WAIAKEA-PALAI STREAMS Hilo, Island of Hawaii, Hawaii

CONTINUING AUTHORITIES PROGRAM SECTION 205
FLOOD RISK MANAGEMENT

Appendix F: Public Involvement

May 2020

OVER FOR MAP

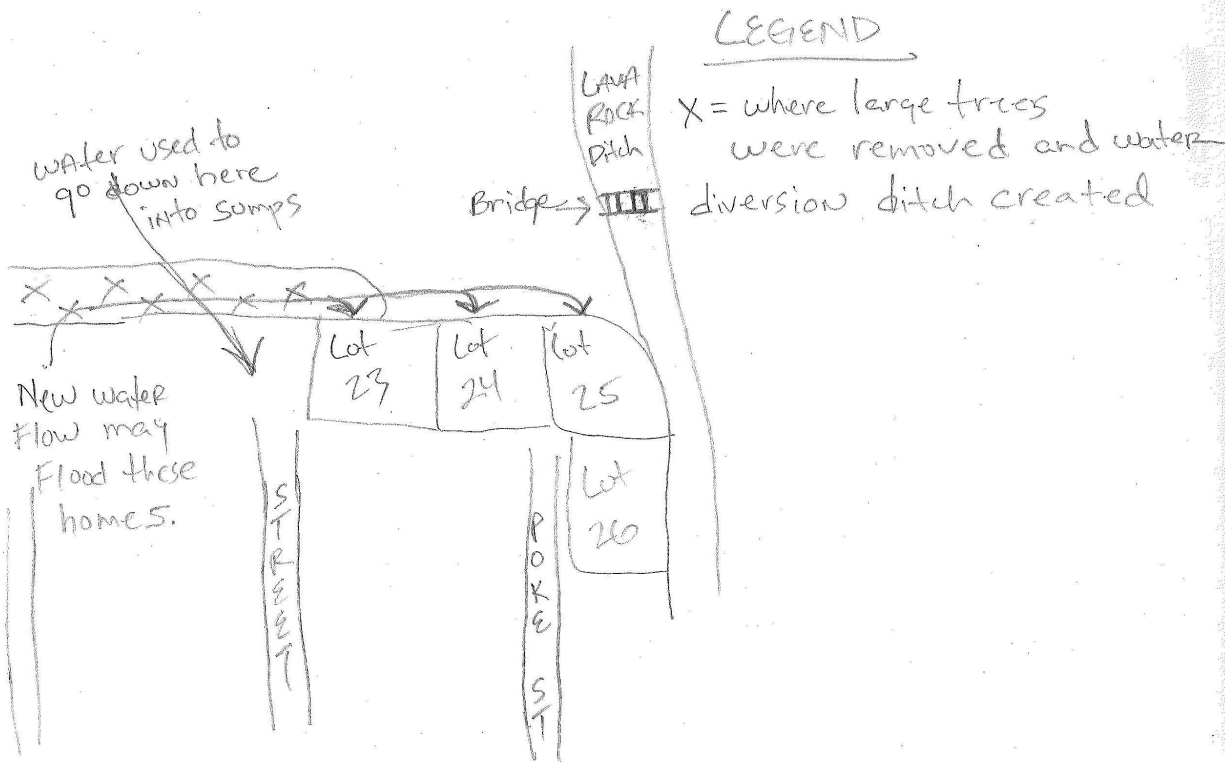
Re-iterating on Sunshine Carters question tonight, In the last 2-3 weeks, the county cleared an enormous amount of trees and appeared to create a ditch or diversion of natural water flow on the makai (ocean) side of hole # III. It appears this will divert more water towards Hemakua direction towards the lava rock gulch. Problem is this may cause flooding over a small bank along lot (2-4-084-024) and adjacent parcels which never flooded before. County did this without any notice to homeowners. WAS FEMA notified and was this done with permission and/or permits? (Please use back of sheet if needed)

This comment has been provided to the County for local coordination and follow-up.
